SUBSURFACE WASTEWATER DISPOSAL SYSTEM APPLICATION

SUBSURFACE WASTEWATER DISPOSAL PLAN

Subject: New System Variance denial, Nicknain property, Burns Road, Augusta

SUBJECT: New System Variance Approval, Nicknair property, Burns Road,
Augusta

SUBSURFACE WASTEWATER DISPOSAL PLAN

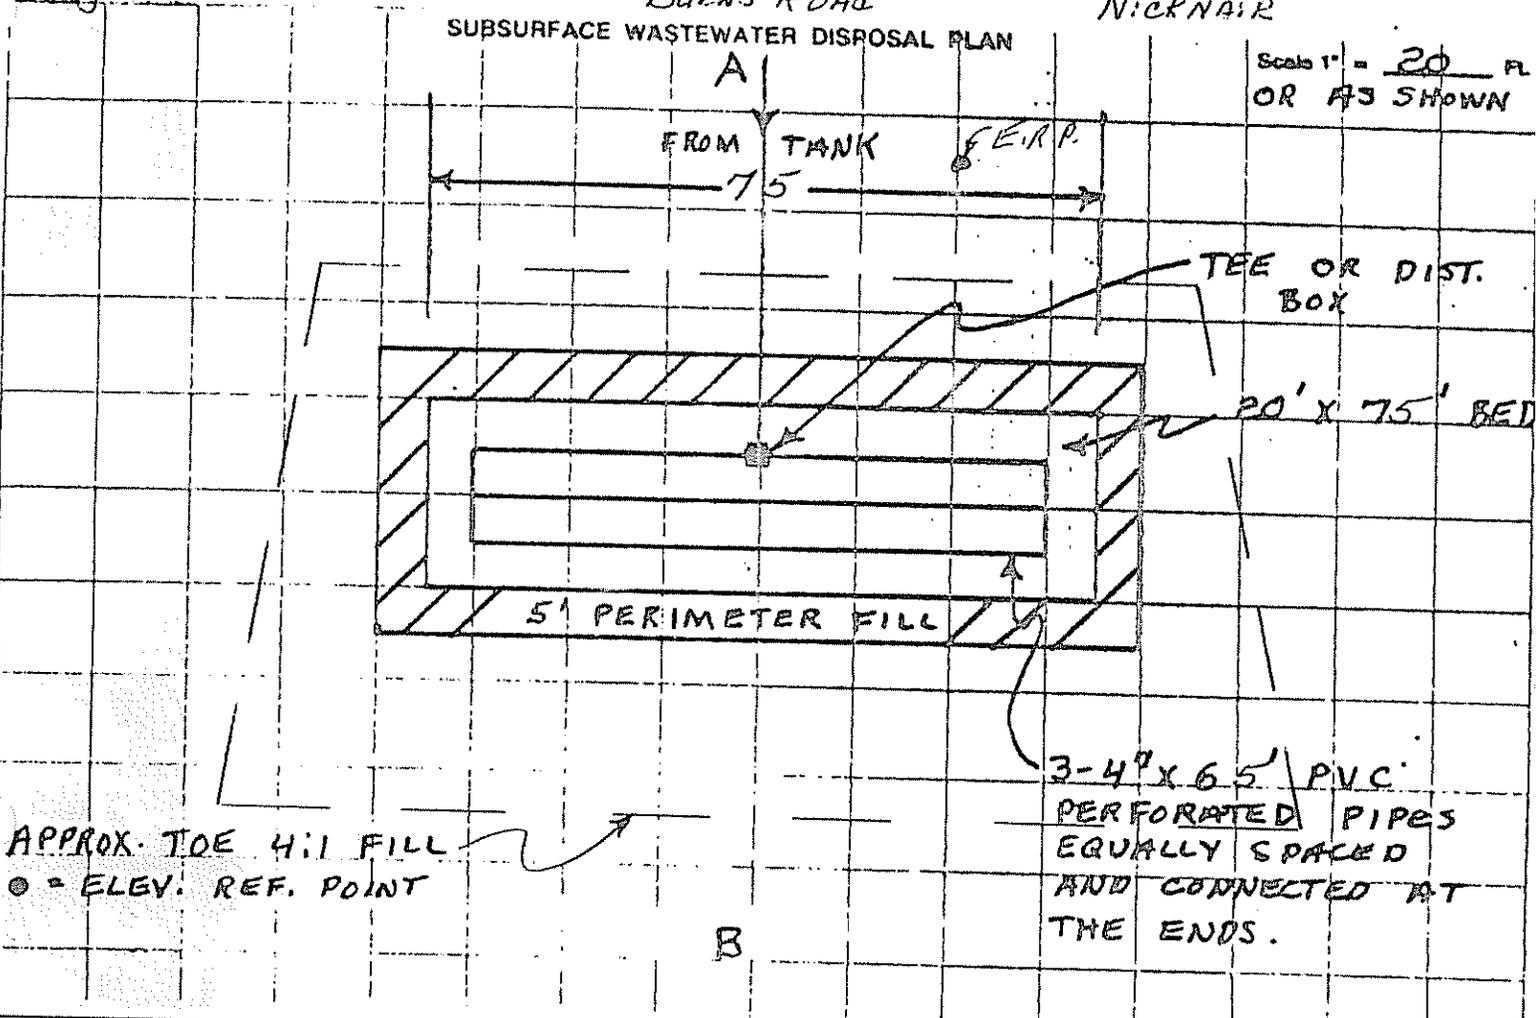
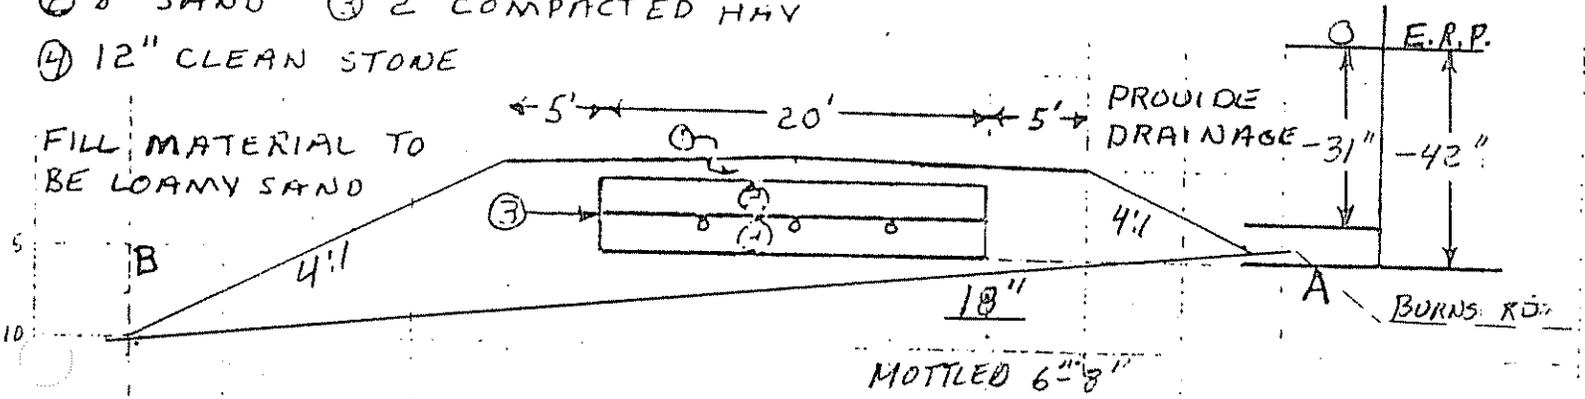
This office does not feel that the proposed design is a workable one. Specifically, the very high groundwater table combined with a relatively low potential score of 53 points indicates a poor potential for the treatment of wastewater.

I suggest that you contact Mr. Rideout, SE to have the design revised to incorporate an extra 6 inches of fill or to explore the possibility of disposal elsewhere on the site. You may submit a revision at no additional cost.

FILL REQUIREMENTS		CONSTRUCTION ELEVATIONS		ELEVATION REFERENCE POINT LOCATION & DESCRIPTION	
Depth of Fill (Upslope)	36"	Reference Elevation is	0	NAIL IN CMP POLE # 88/33	
Depth of Fill (Downslope)	48"	Bottom of Disposal Area	-42"		
		Top of Distribution Lines or Chambers	-31"
